# DOCUMENT 00 90 10

## ADDENDUM No. 1

- A. The Construction Contract is known as North Street, Harrisville to Wall.
- B. Date of this Addendum: February 14, 2023.

North Street- Harrisville to Wall

C2.2

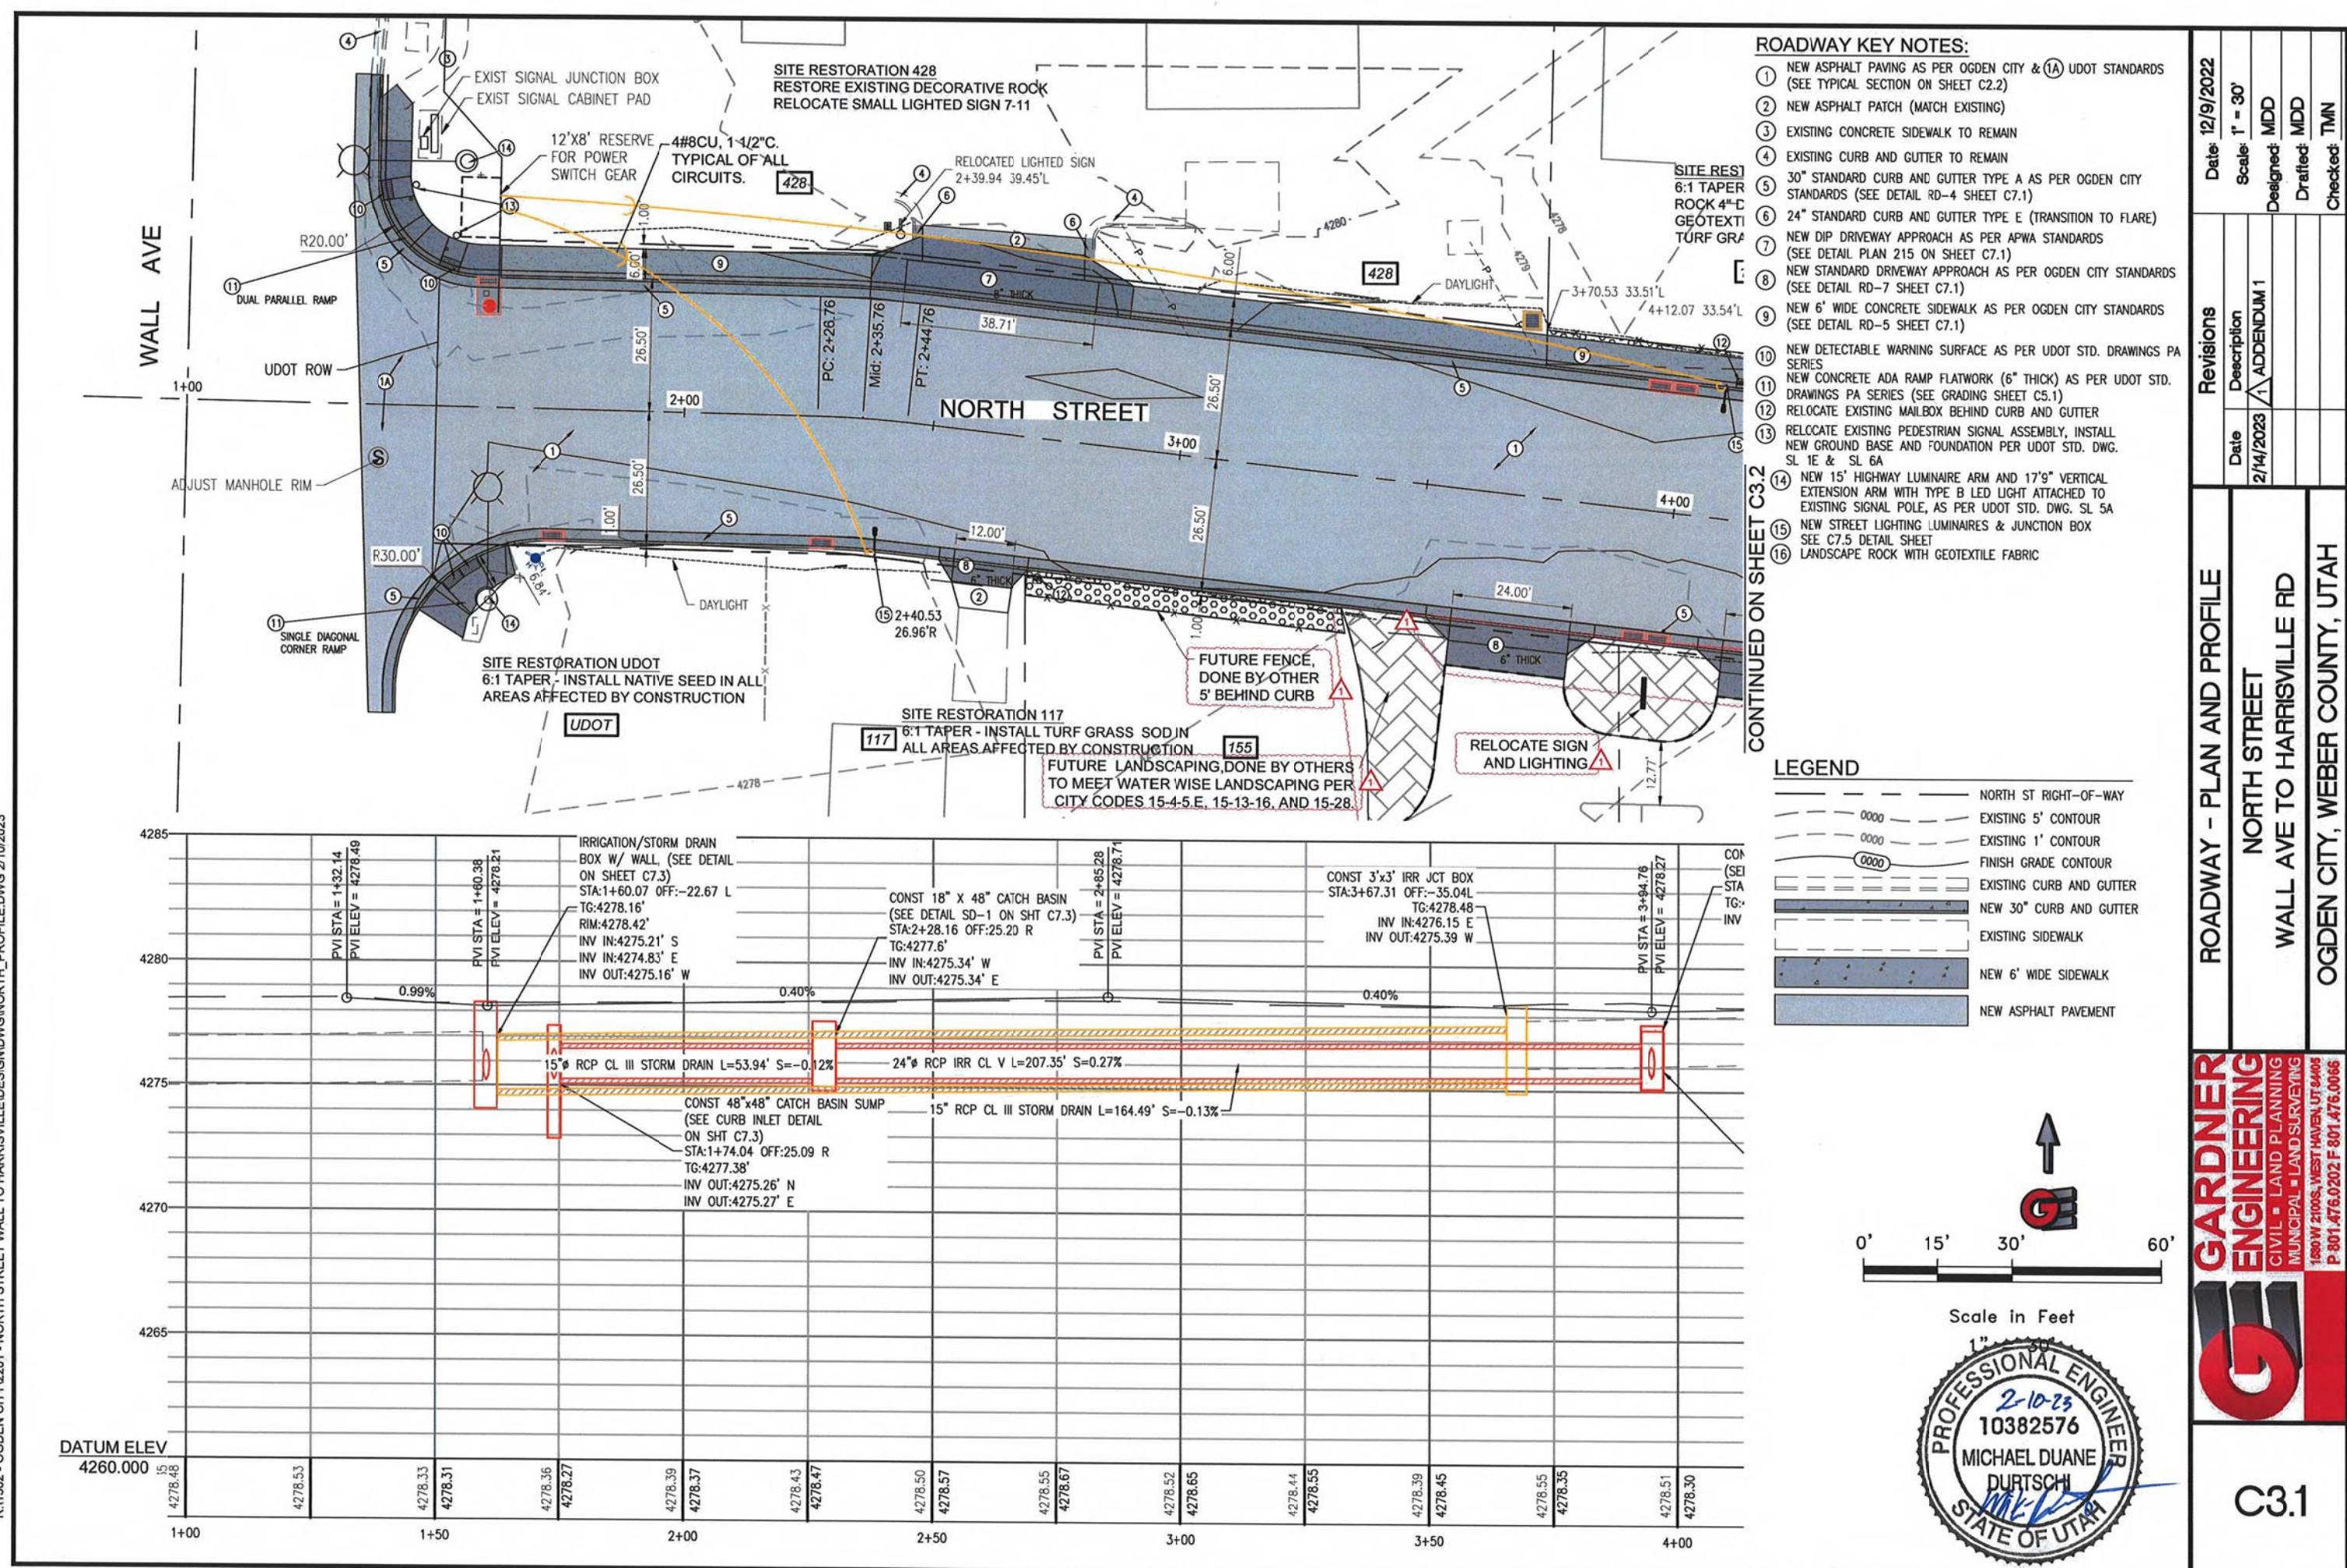
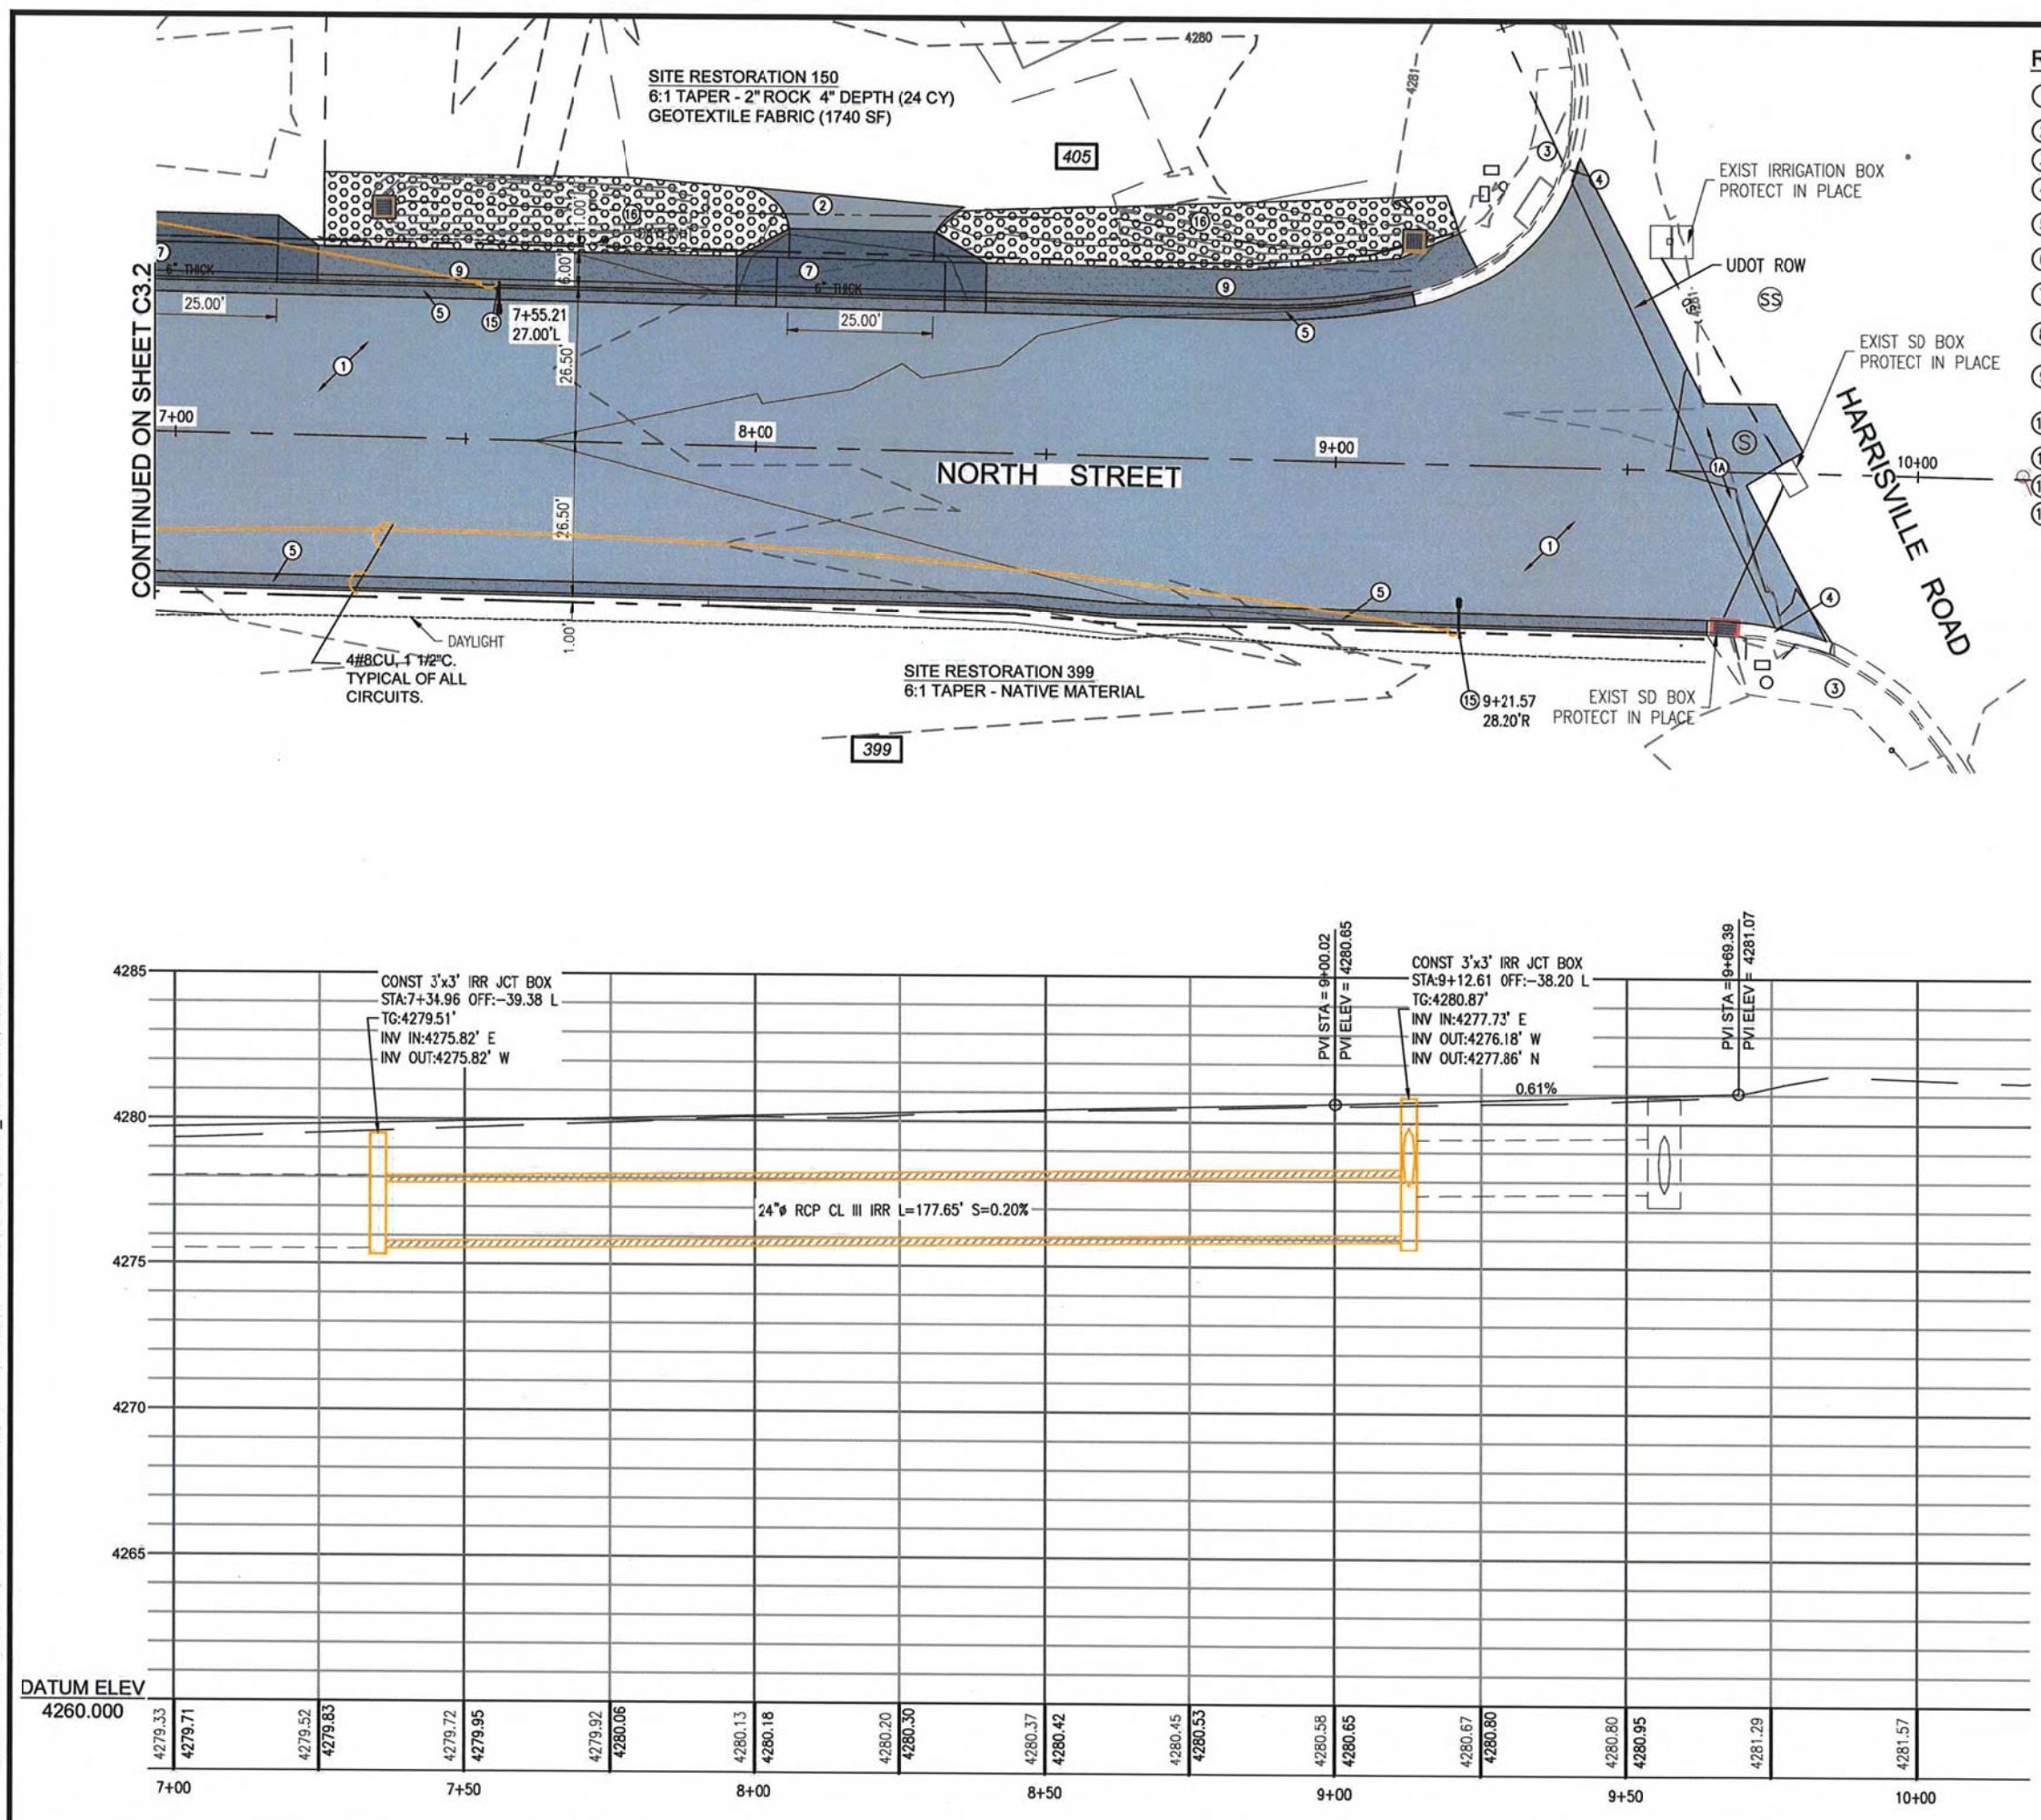
- ii. ADDED TREE REMOVAL AT STA. 6+17.
  - iii. SAW CUT AND REMOVE ASPHALT ITEMS UPDATED.
- D. Add the following changes to Sheet C2.2 Roadway Sheet:
  - i. Remove/delete callout from “TYPE 2 EMULSIFIED ASPHALT SLURRY SEAL OR UDOT TYPE “C” CHIP SEAL AS SPECIFIED BY CITY ENGINEER”.

- ii. Sidewalk depth and UTBC depth changed from “4” to “6”.
- E. See Sheets C3.1-C3.2 and C5.1-C5.2 for the following updated items:
  - i. Lay out change at DRIVEWAY ENTRANCES TO BUDDHIST CHURCH.
